Technical Service Bulletin: tsb100158

New Alternator Belt Tensioner And New Belt Material

This Technical Service Bulletin introduces a new design alternator belt tensioner, and a new alternator belt material for the QSK45 and QSK60 series engines.

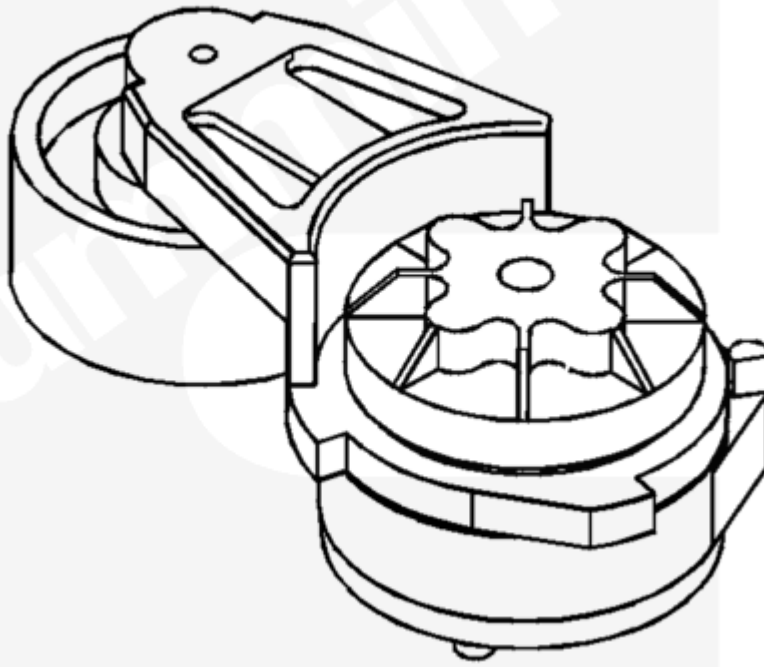
The old alternator belt, Part Number 3171732, is made of reinforced neoprene and is susceptible to cracking on construction applications. The new belt is constructed from a hybrid 'Orion QT' neoprene, alkylated chlorosulphonated polyethylene material. The new belt Part Number is 4066750.

Old Belt Tensioner (4000980)

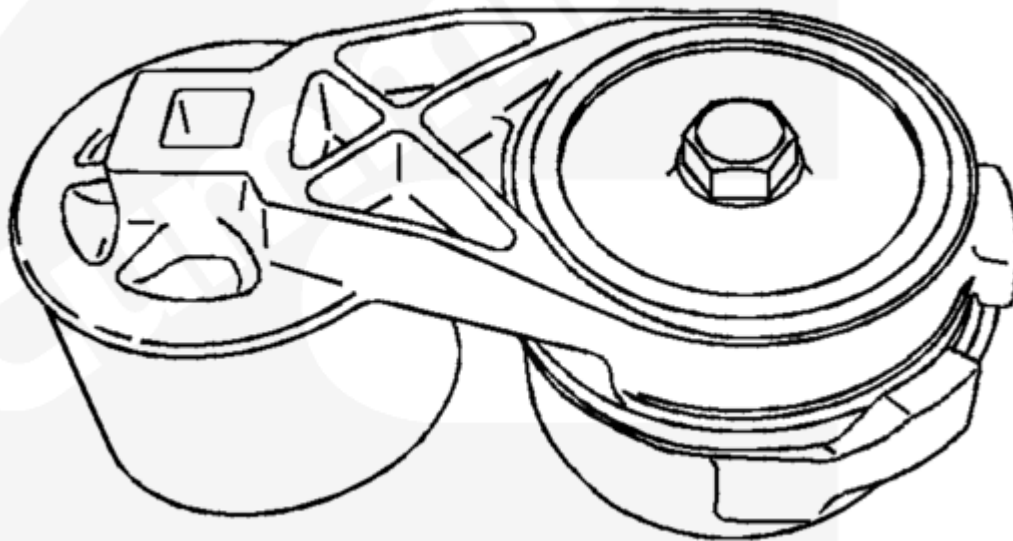
The old design alternator belt tensioner is Part Number 4000980. This design was experiencing bearing and bushing wear, due in part to ingress of dirt. The new belt tensioner, Part Number 4086084, provides three times improvement in life expectancy. The new design has two main new features:

1. A cast shield to protect the bearing from dirt ingress.
2. A T-profile spring bushing and labyrinth damper seal to prevent dirt ingress to bushing wear areas.

New Belt Tensioner (4086084)
